Town of Hilton Head Island

Design Review Board Meeting

**Fist African Baptist Church
70 Beach City Road
Final
Response Letter to Conditions
November 25, 2025
DRB-001095-2025**

**First African Baptist Church
70 Beach City Road
Final Set Plan Set
November 25, 2025
DRB-001095-2025**

4 Stained Glass Window Detail
1" = 1'-0"

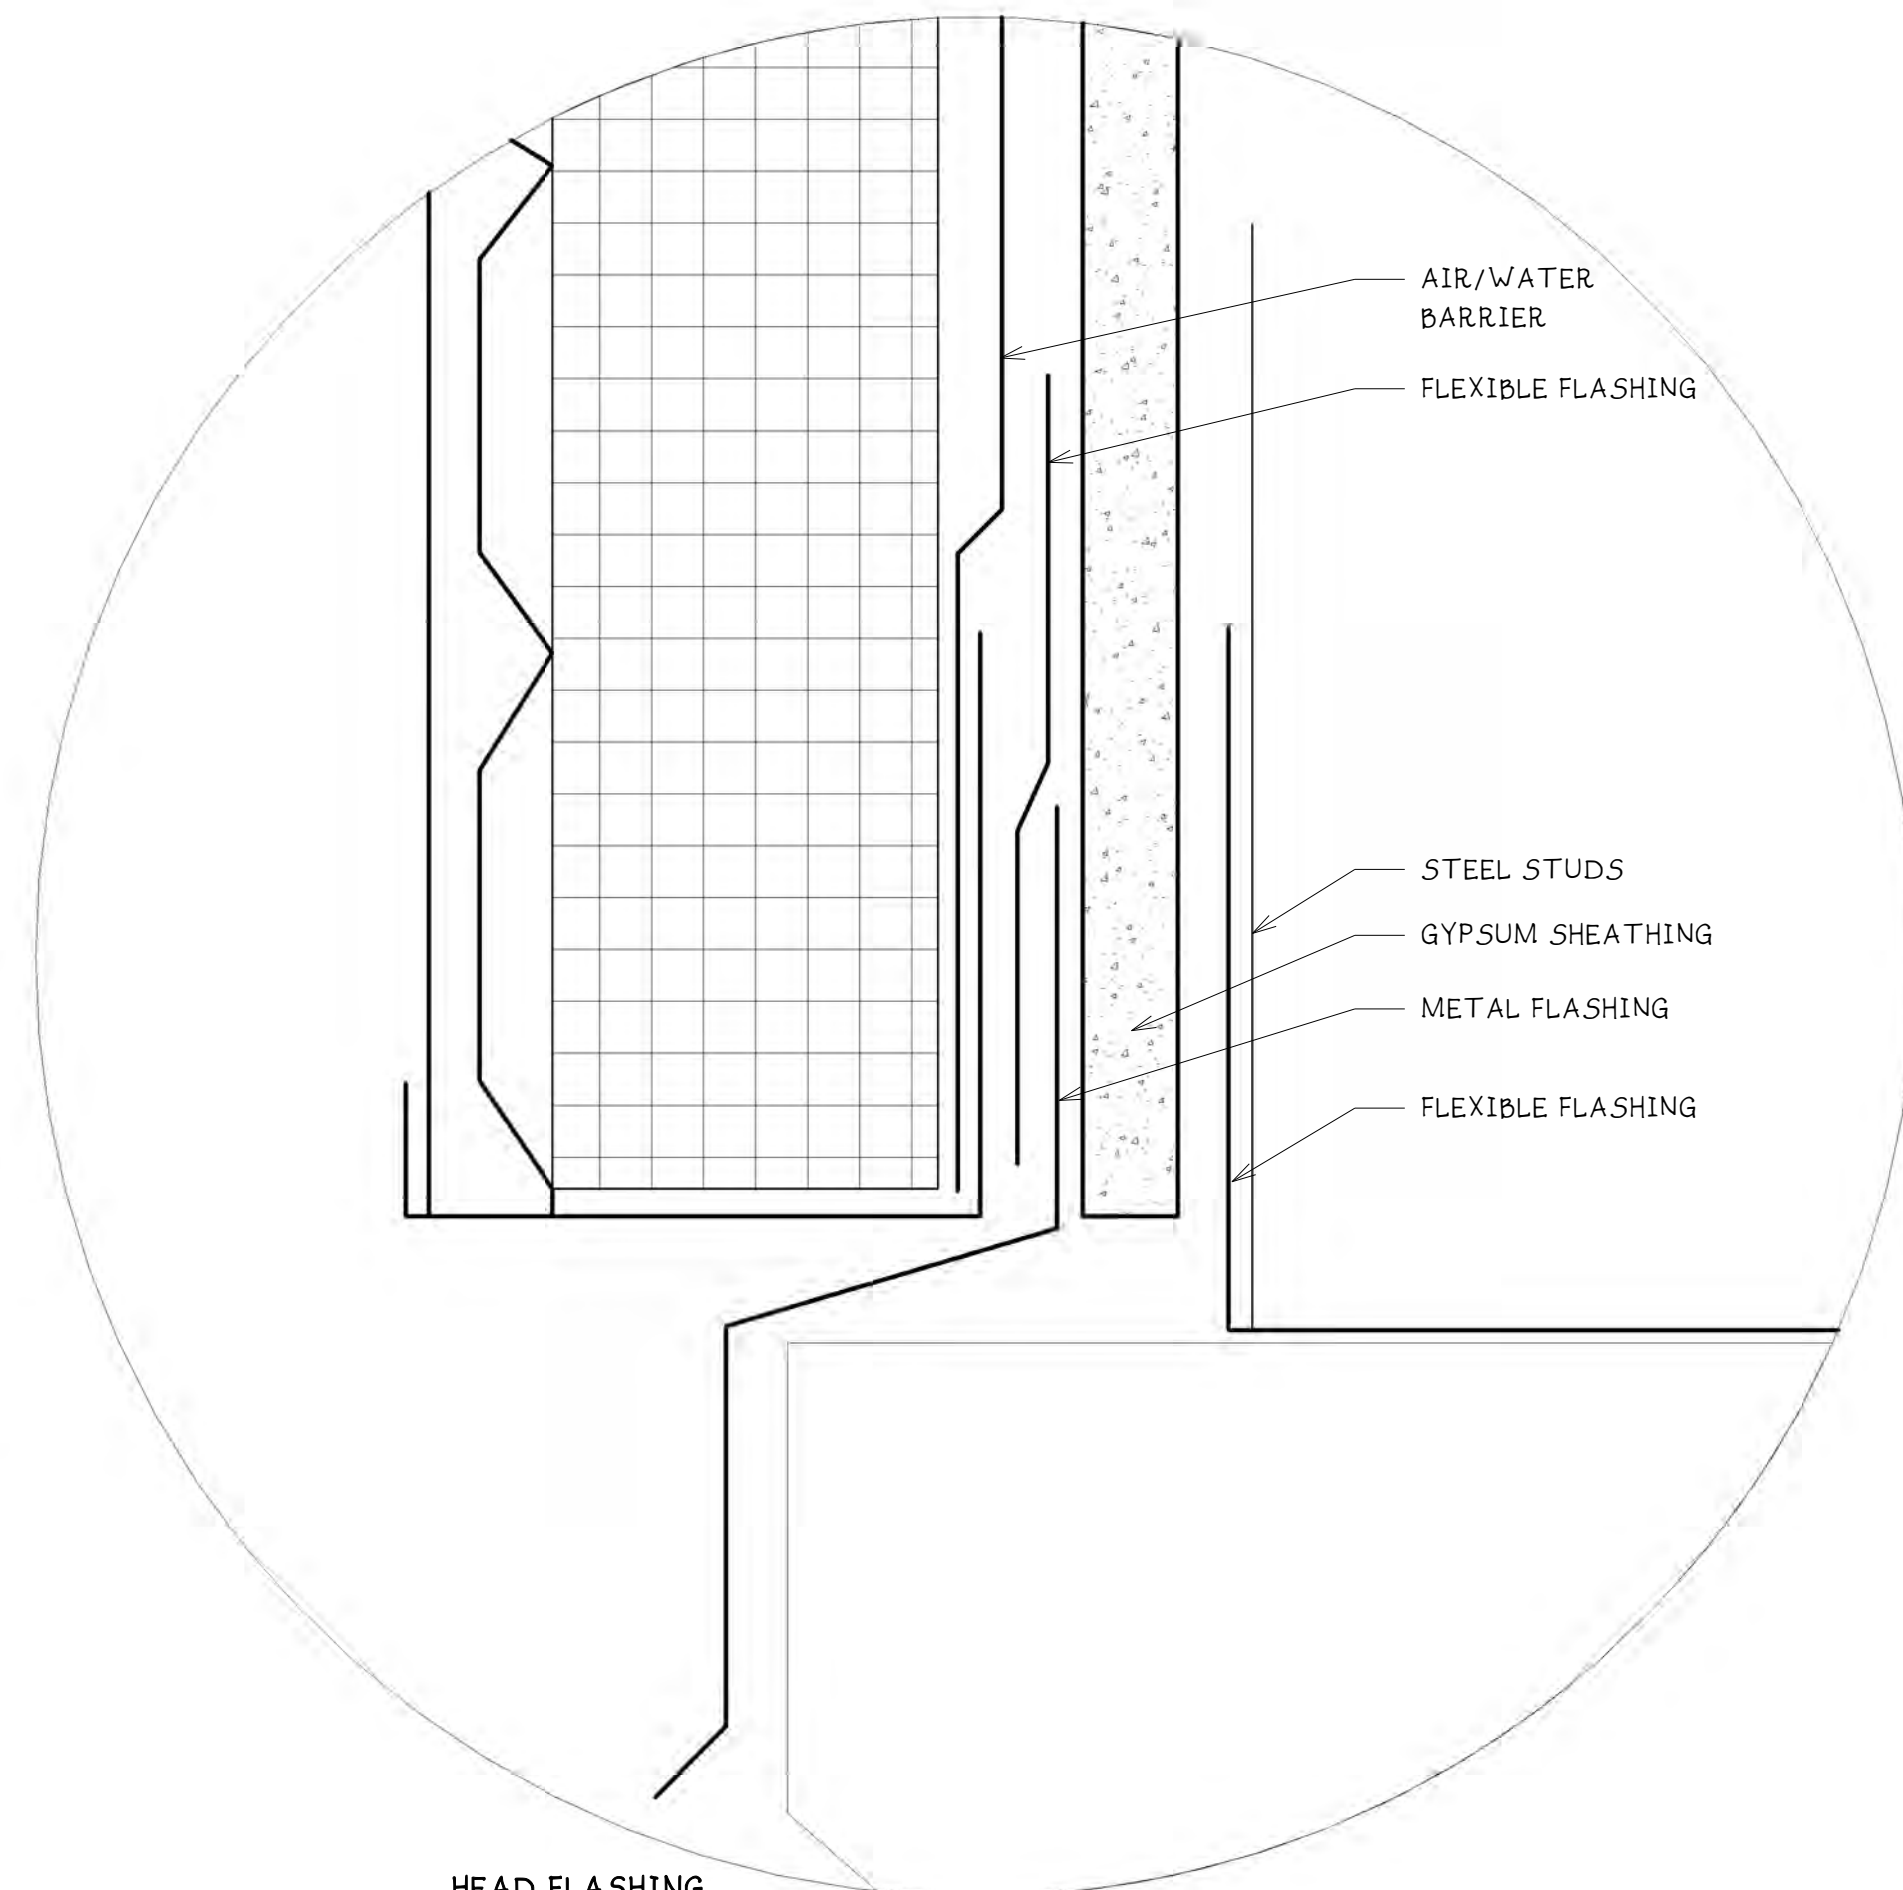
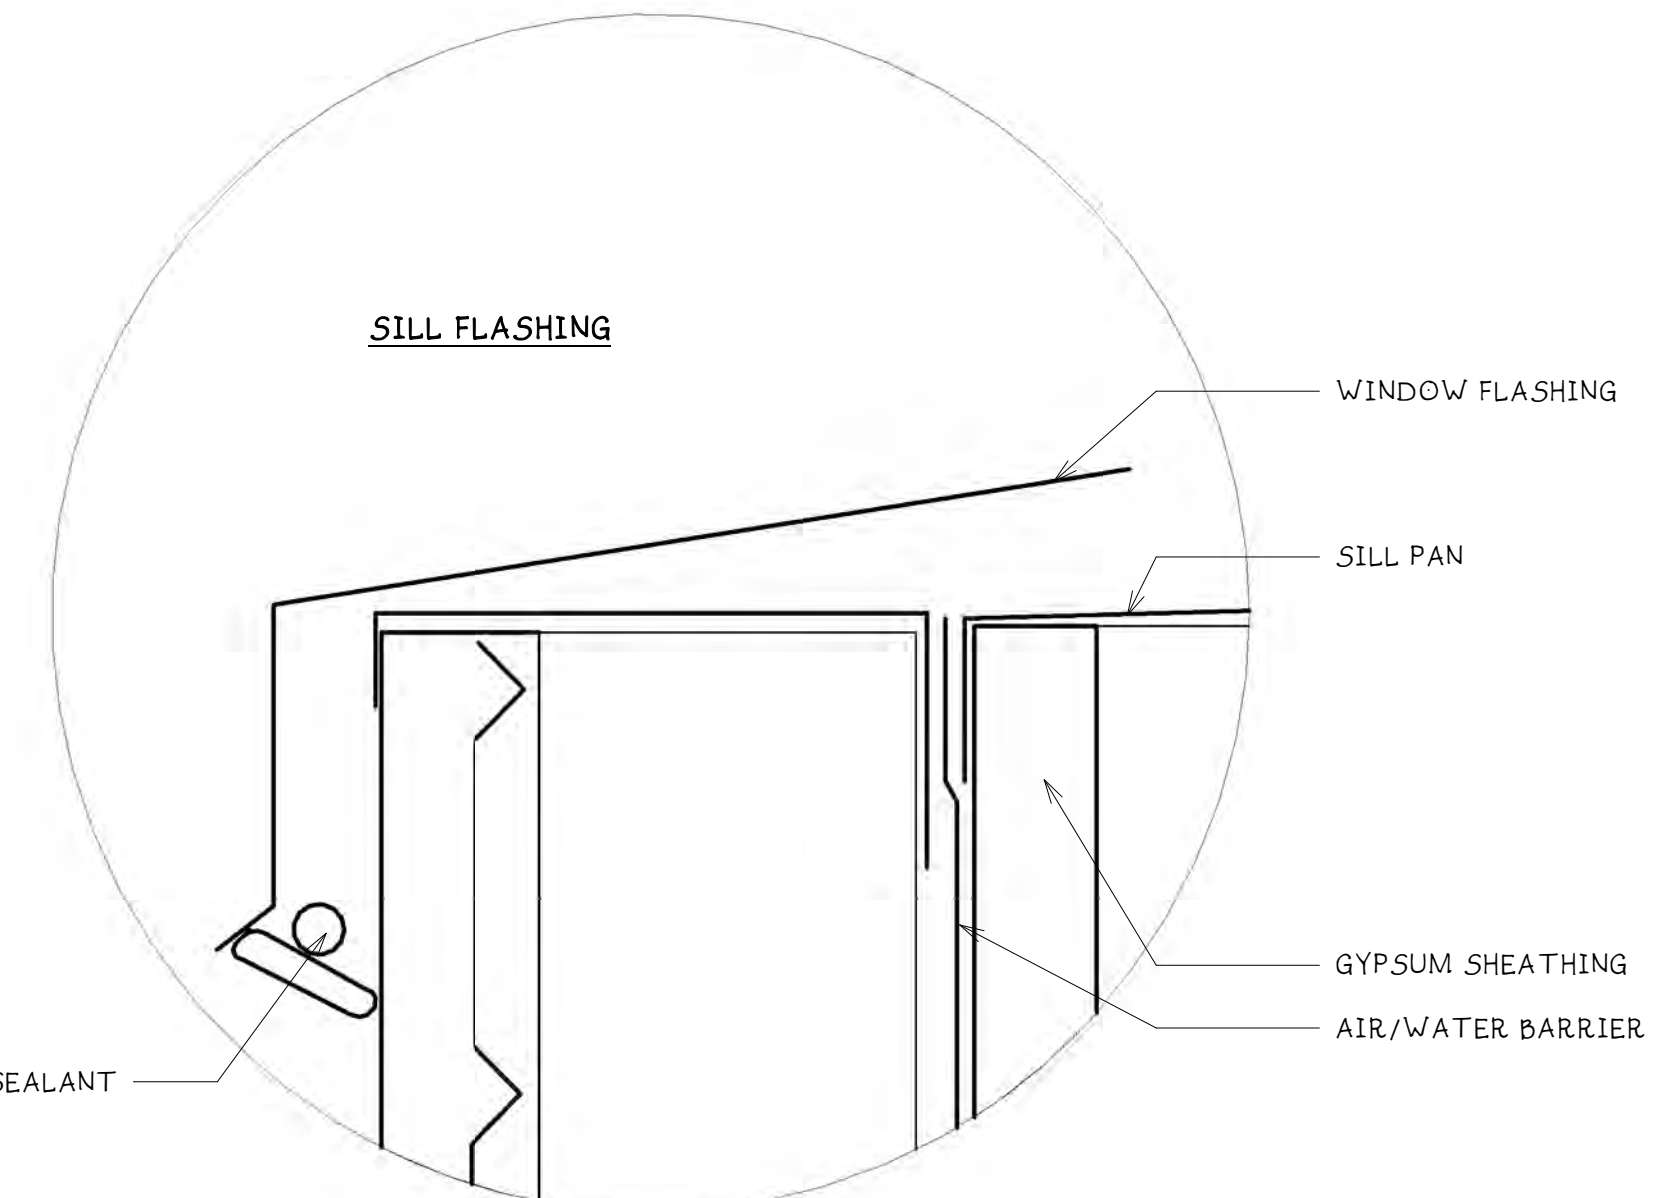
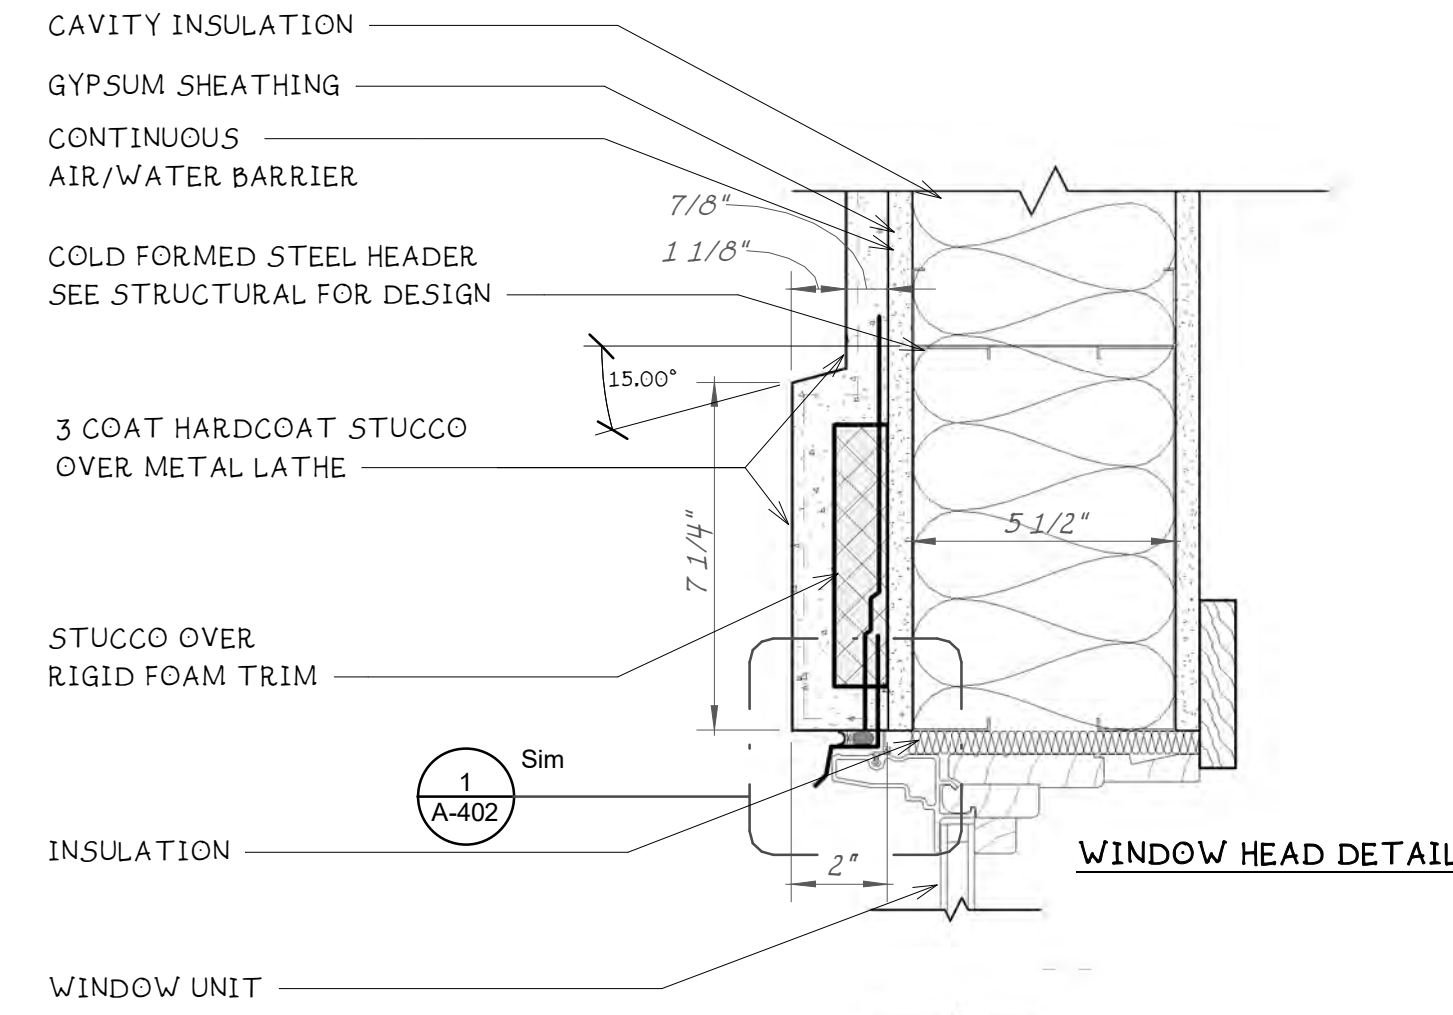
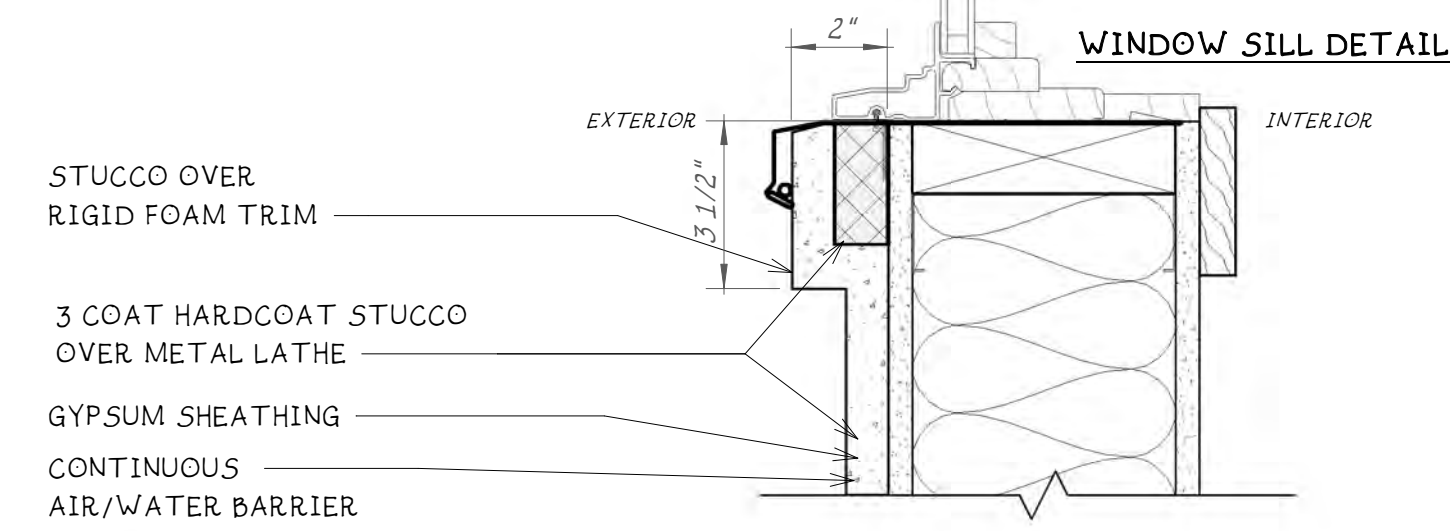
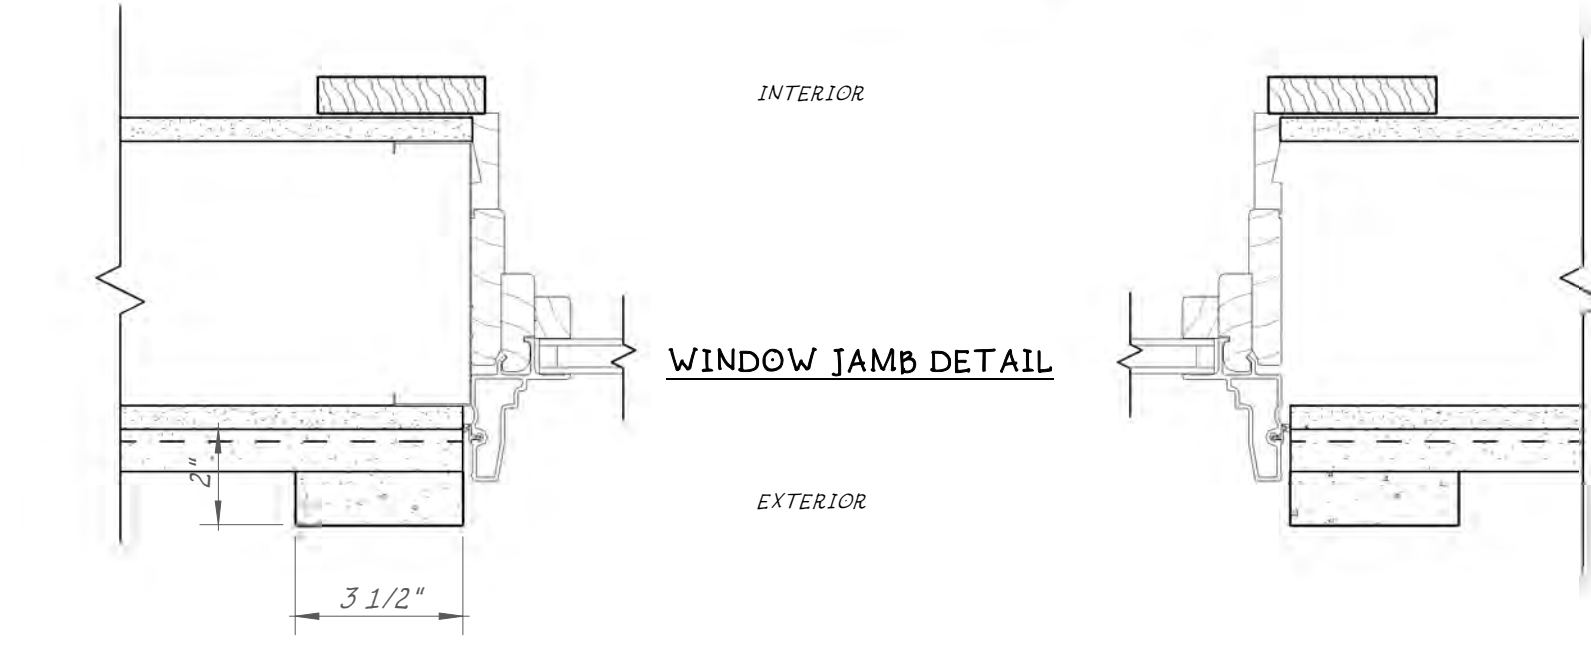
6. Show the entry door detail (head, jamb, sill).
 - a. Entry door detail is shown
7. Include foundation plantings in the front and around the building, along with palm trees added to the entry.
